CONTRACT CHANGE ORDER NO.

CONTRACT	AWARDED BY:	Fresno City Council		DATE OF AWARD:	November 20t	h 2015	
PROJECT:	Southeast Surface Wa	ater Treatment Facility					
P.O. NO:	FRSNO-0000070070	PROJECT ID N	O: WC00008	57	BID FILE NO:		3369
CONTRACT	OR: W. M. Lyles (Co. of Fresno, California	3		U ==		
The Contrac	ctor is hereby request	ed to make the herein described	changes fron	n the Contract Documents	or do the follow	ing des	cribed work
not included	in the plans and spe	cifications on this contract. NOT	E: THIS CHAN	IGE IS NOT EFFECTIVE U	INTIL FULLY EXI	CUTE	D.
Description	on of Requested C	hange:

City of Fresno Southeast Surface Water Treatment Facility

Change Order Recommendation for COP No. 001

NOTE: Revised Layout Attached

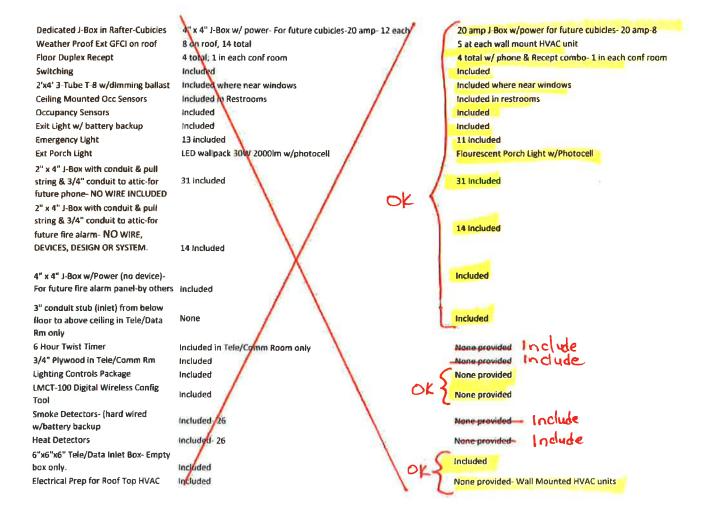
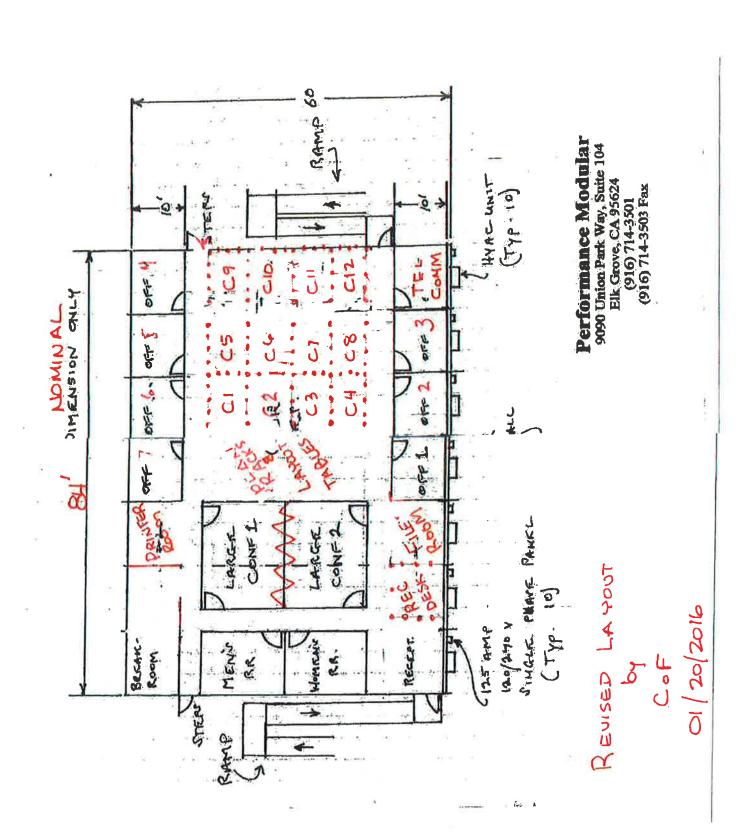
Please provide a change order proposal for incorporating the following changes into the contract:

- Incorporate the attached revised layout and specifications for the Program & Construction Management Office described in Specification 01501. This facility is to be retained by the Owner following completion of the project.
- Delete one refrigerator and one microwave from section 01501,2.12. All other appliances shall be provided as specified.
- Delete the asphalt paving for the CM Complex parking lot and construct parking lot per detail M on drawing 01-C-030 without the asphalt layer.
- Delete the Temporary Field Office described in spec 01501,2.18.

City of Folsom Specs But With OPTION 1 FLOORPLAN PMI Specifications- OPTION 2 FLOORPLAN Specification Item 120' x 60' (116' 8" x 60' actual; +/- 2") NOT PER CITY FLOORPLAN 120' x 60' (116' 8" x 60' actual, 1/- 2") NOT PER CITY FLOORPLAN Floorplan Not-included Include Fire Sprinklers Included Not included. Wall mounted units w/return air plenum included. Roof Top HVAC units Included No balance included Include Certified Air Balance Included Not included oclude Title 24 Energy Calcs Included 2013 Energy code, Part 6, Title 24, Not included Include Included CCR 2013 Energy Commission Bldg Energy Included -Not-included Include Efficiency stds & reg'ts 2013 energy code, Title 25, Article 3, 2013 Energy code, Title 25, Article 3, Section 4369B Included 2013 Energy Code, Title 25, Article 3/Section 4369A included Section 4369B Steel Outrigger Type Frame with 2" x 8" Floor joists Steel Perimeter Type Frame Frame Type Floor:R-30; Walls: R-19 & Roof: R-30 Floor:R-30; Walls: R-19 & Roof: R-30 Insulation 2" x 6" Exterior wall stud size 2" x 6" 3/4" T & G Plywood 3/4" T & G Plywood Floor Decking Floor Covering- Restrooms Restrooms: Sheet viny 6" self cove Restrooms: Sheet vinyl w/6" self Cove Floor Covering-Janitors, kitchen, 1/8" VCT w/ 4" rubber base in Breakroom, Reception & Tele/Data 1/8" VCT w/ 4" Rupper Base oK-NOTE: No Showers included shower & Reception 26 oz, Direct Glue Down, Polypropylene, with 10 year standard warranty-Carpet- 20 of Direct Glue Down (Spec calls for 17 oz), Polypropylene, Floor Covering-All other areas CARPET TILE NOT PROVIDED. with 10 year standard warranty- CARPET TILE NOT PROVIDED Exterior Wall Finish LP Smart Panel Siding LP Smart Panel Siding 1/2" vinyl covered gypsum Interior & Exterior wall finish 1/2" vinyl covered gypsum RA1 Insulation None-provided Provide Interior wall insulation

Not included. Not using original floorplan, using PMI Floorplan NOT INCLUDED. BLOCKING PROVIDED ONLY

Not included. Not using original floorplan, using PMI Floorplan NOT INCLUDED, WALL MOUNT HVAC UNITS
